Re: Florida Power & Light Company
Proposed Turkey Point Units 6 and 7
Docket Nos. 52-040 and 52-041
Response to NRC Request for Additional Information Letter No. 037
(eRAI 5896) SRP Section - 02.05.02 Vibratory Ground Motion

NRC RAI Letter No. PTN-RAI-LTR-037

SRP Section: 02.05.02 - Vibratory Ground Motion

NRC RAI Number: 02.05.02-2 (eRAI 5896)

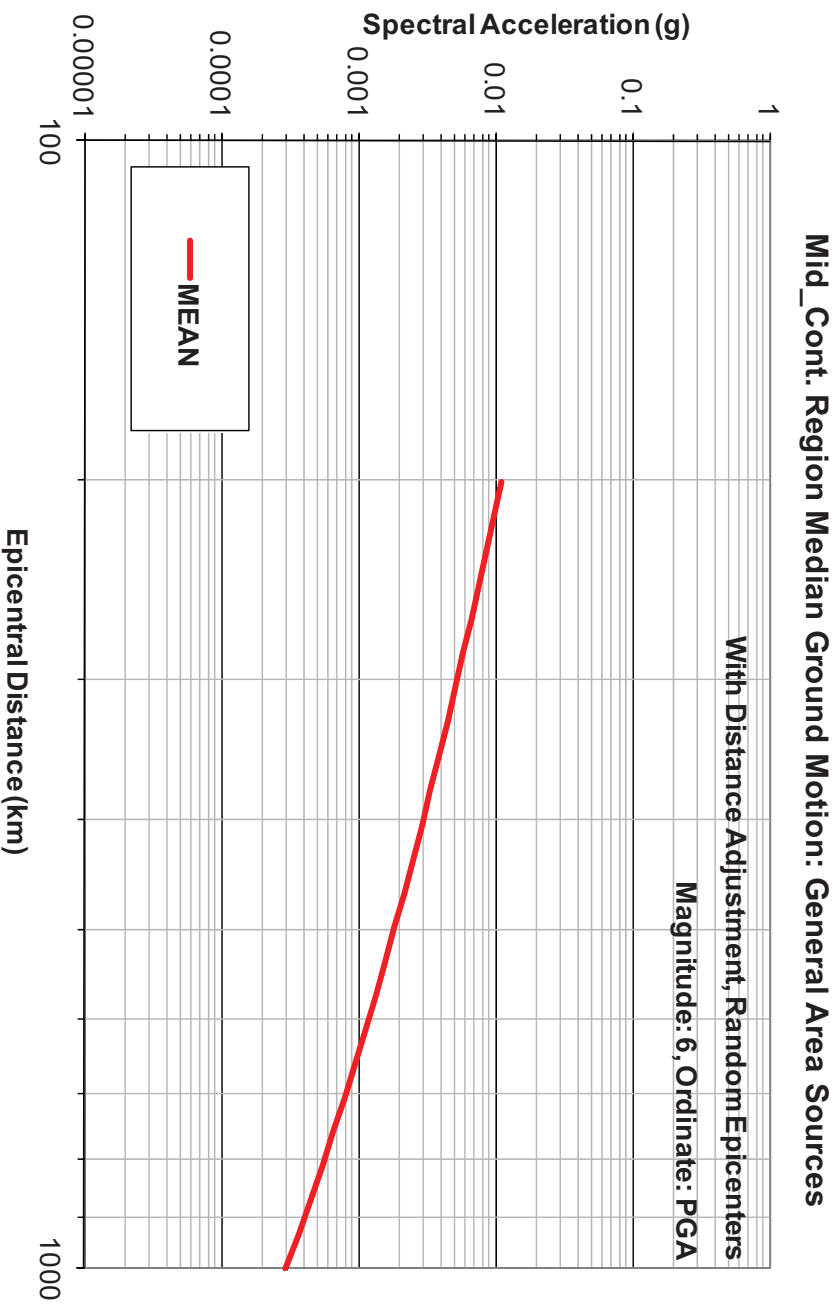
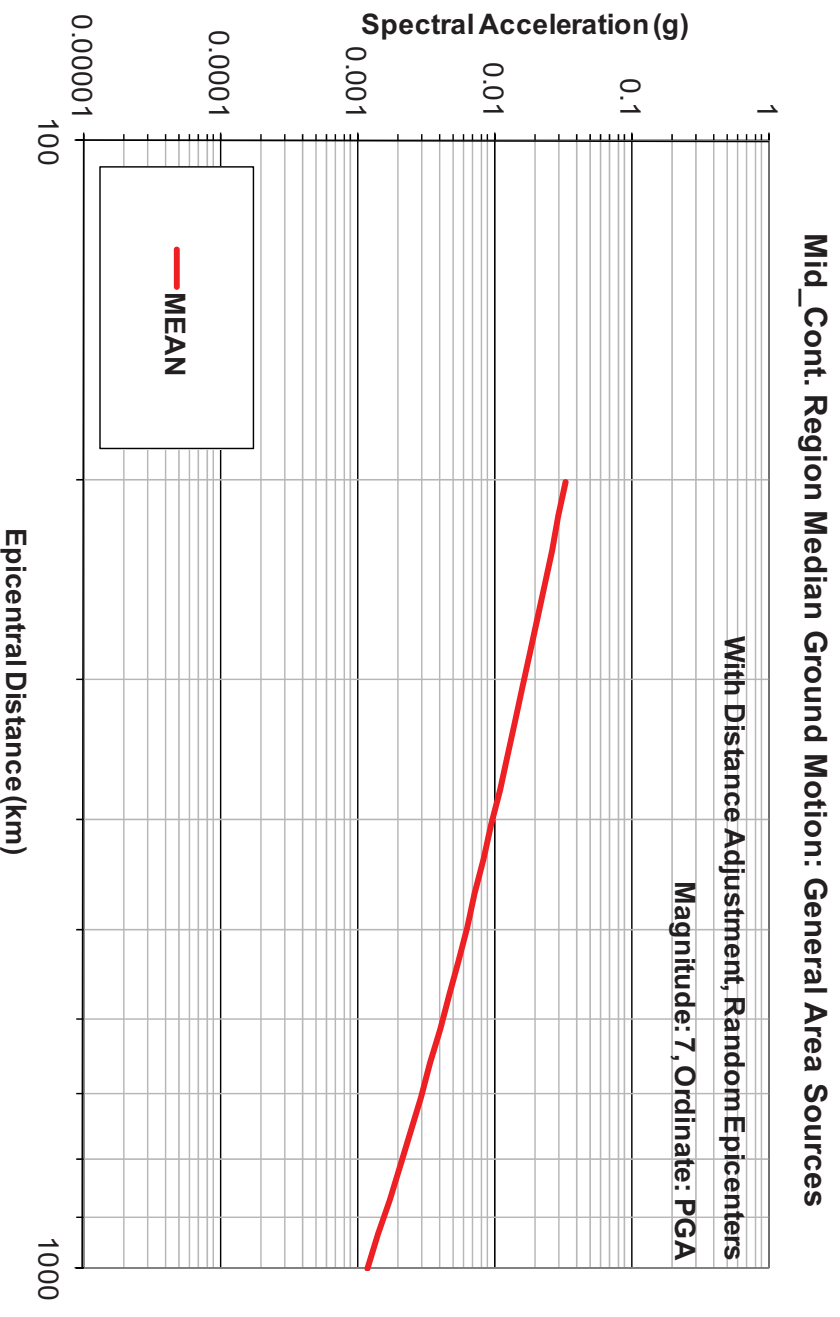
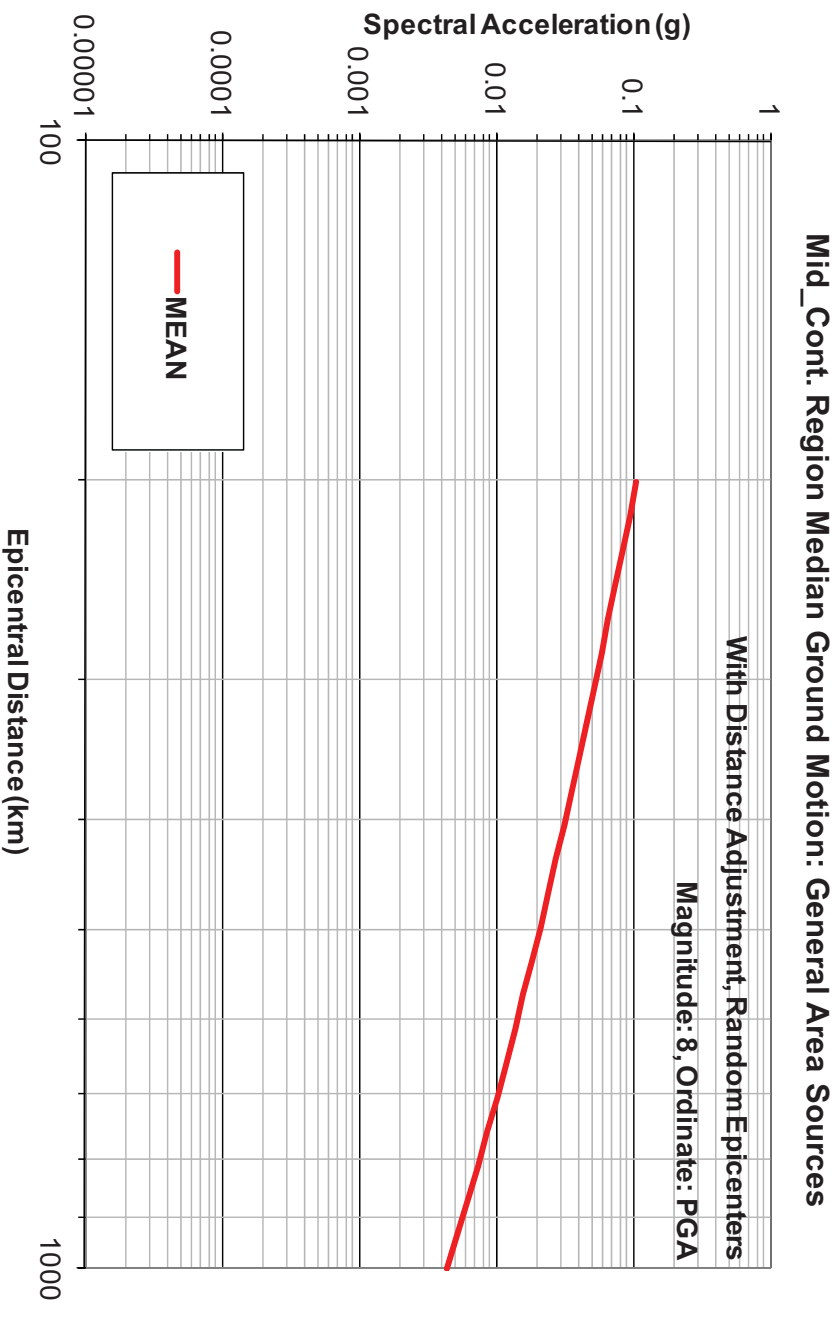
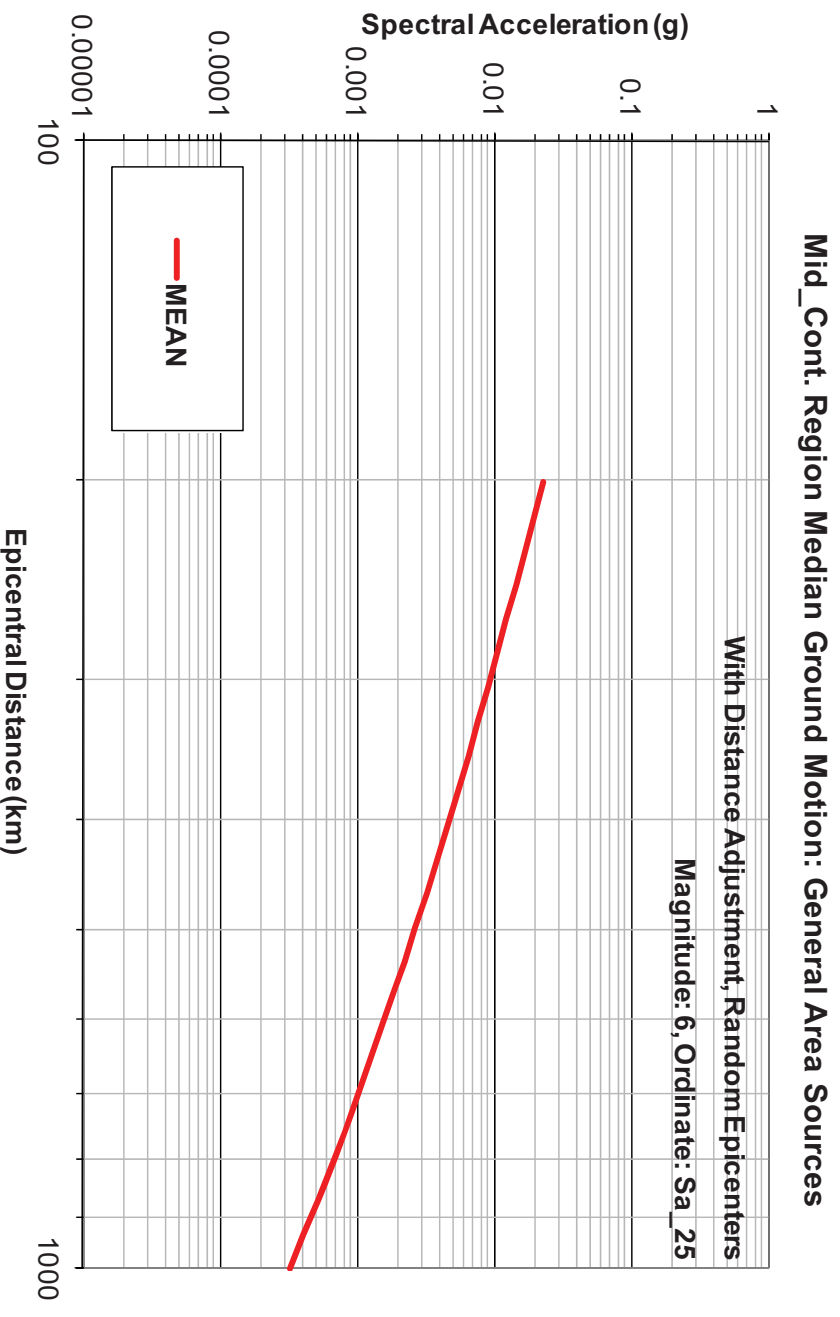
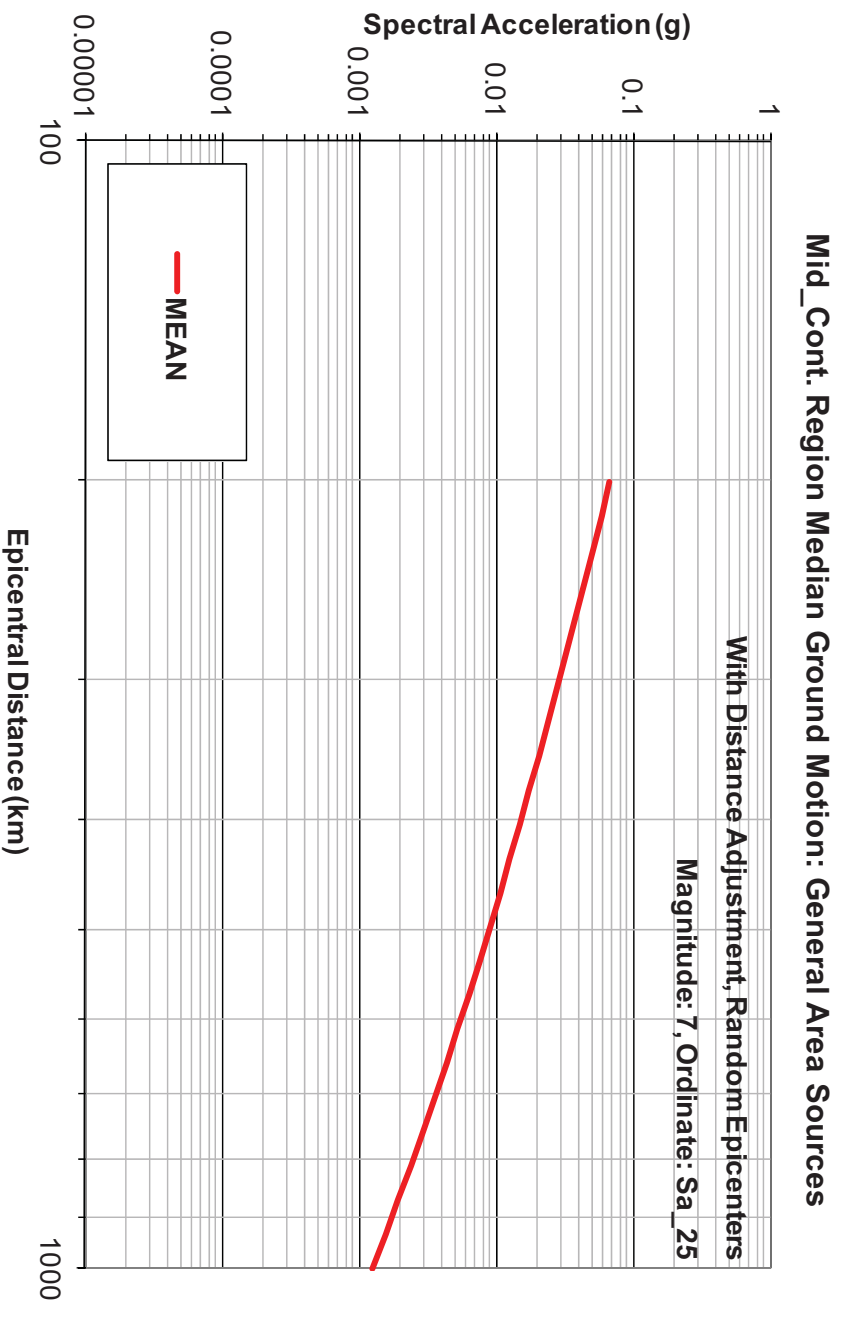
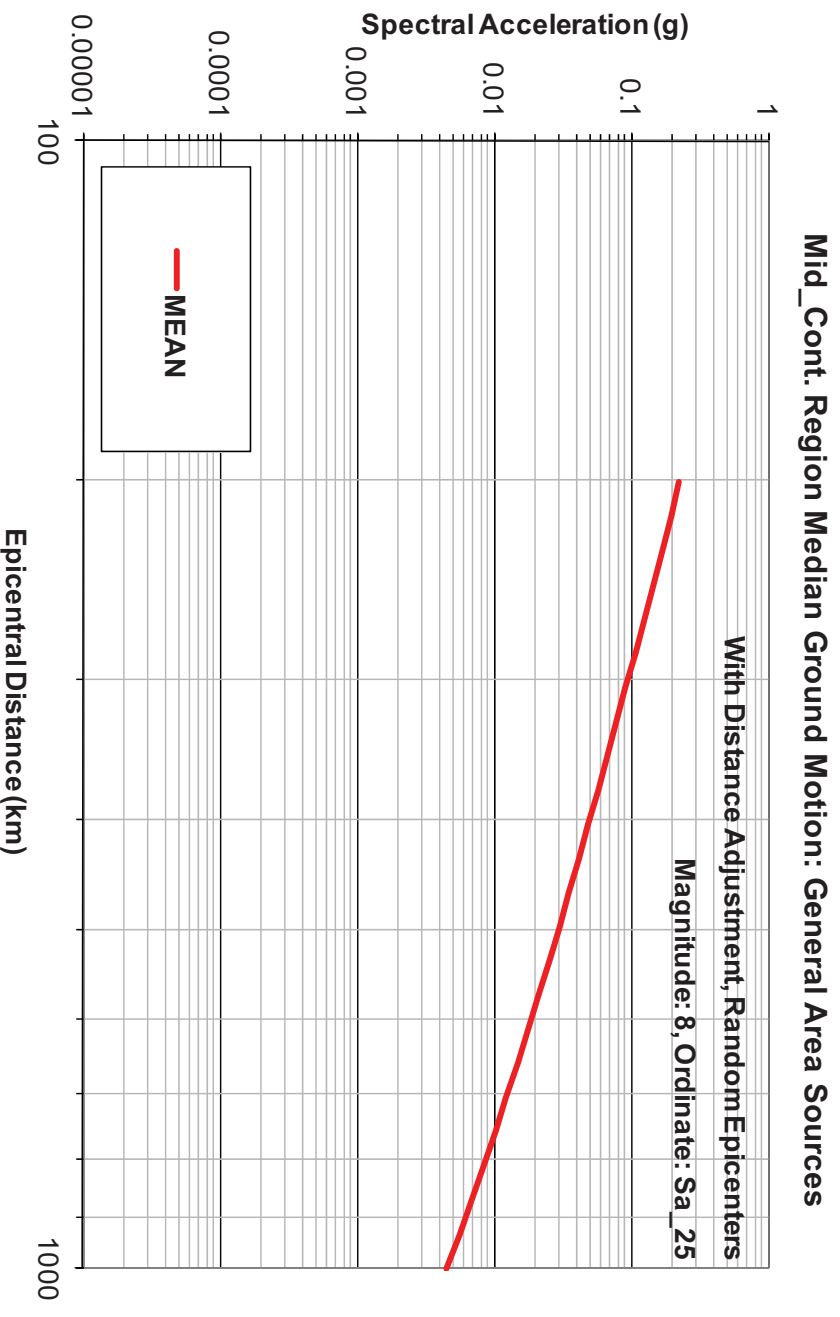
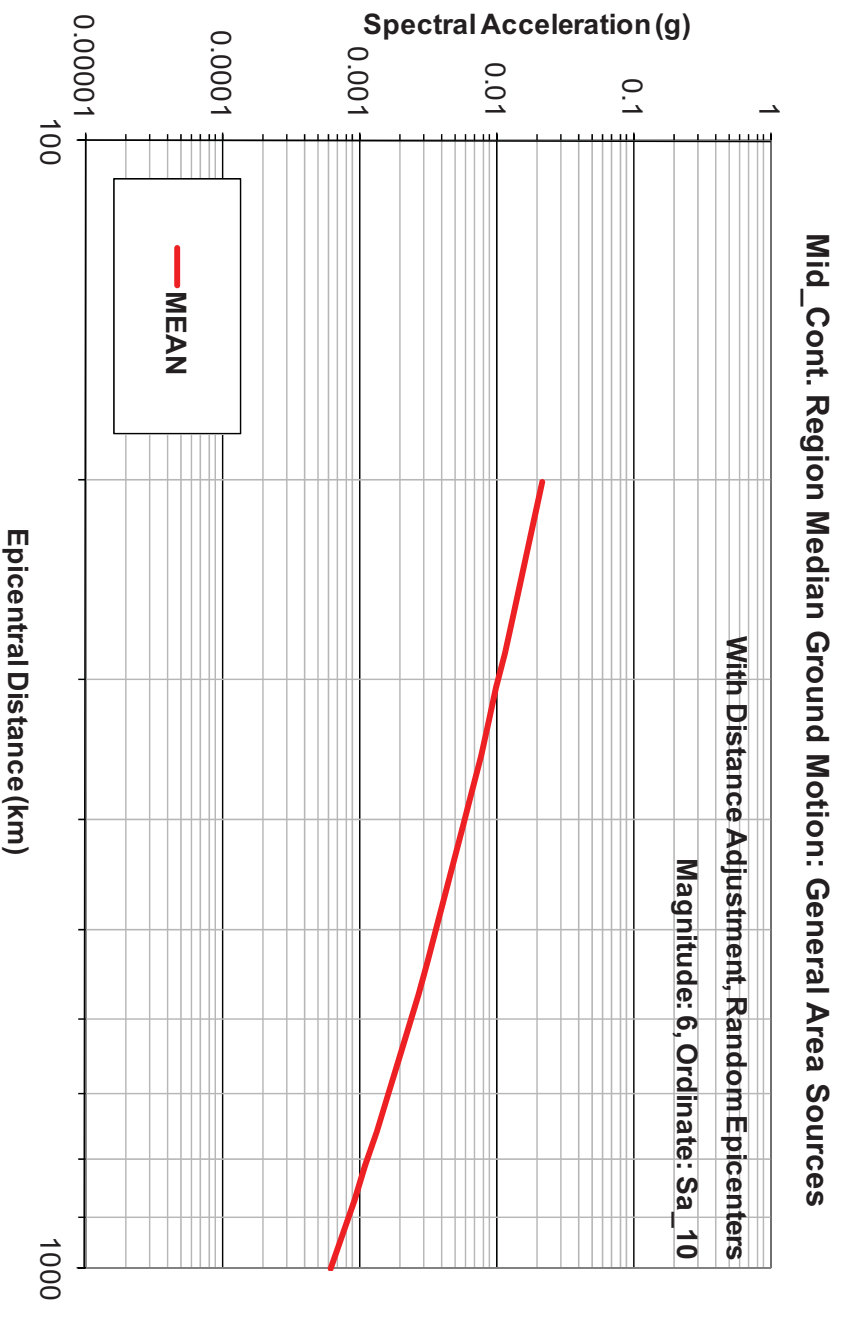
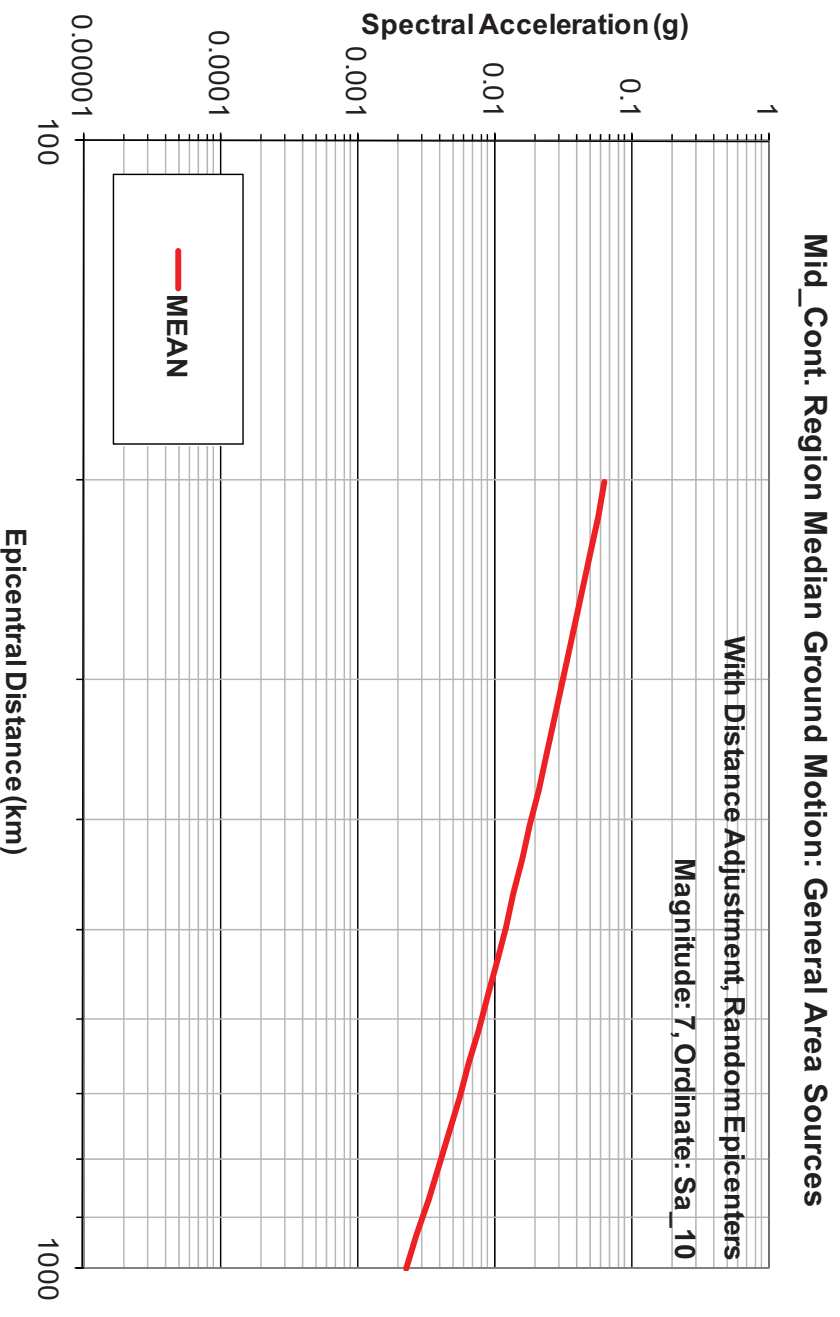
- d. In order for the staff to be able to compare the new Caribbean GMPEs with the 2004/2006 EPRI mid-continent GMPEs, please provide plots showing both ground motion models for earthquake magnitudes of 6.0, 7.0, and 8.0 in the distance range of 200 km to 1000 km at all seven frequencies defined in the EPRI 2004 and 2006 GMPEs.

Ground motion attenuation curve plots are provided for the EPRI (FSAR References 242 and 203) and Caribbean ground motion prediction equations (GMPEs). Note that EPRI (FSAR Reference 203) is only a recommendation for the associated aleatory uncertainty and therefore does not impact the comparison plots of the weighted mean ground motion

attenuation curve. The plotted mean attenuation curve is the weighted mean of the individual median attenuation curves as defined in EPRI (FSAR Reference 242). These attenuation plots are provided for three specific moment magnitude (M_w) values: 6, 7, and 8 for distances between 200 km and 1,000 km. Note that the EPRI (FSAR Reference 242) ground motion attenuation model is defined as a function of epicentral distance, whereas the Caribbean ground motion attenuation model is defined as a function of hypocentral distance. However, because the closest distance is 200 km, the difference between the epicentral and hypocentral distances would be less than 1% for a typical crustal depth of 10 km and even smaller for larger distances out to 1,000 km.

The weighted mean ground motion attenuation curves for the EPRI (FSAR Reference 242) model are given in Figures 1 through 7 for the three magnitudes and seven spectral frequencies requested in the RAI. The weighted mean Caribbean ground motion attenuation curve plots for the same suite of magnitudes, distances, and spectral frequencies are shown in Figures 8 through 14.
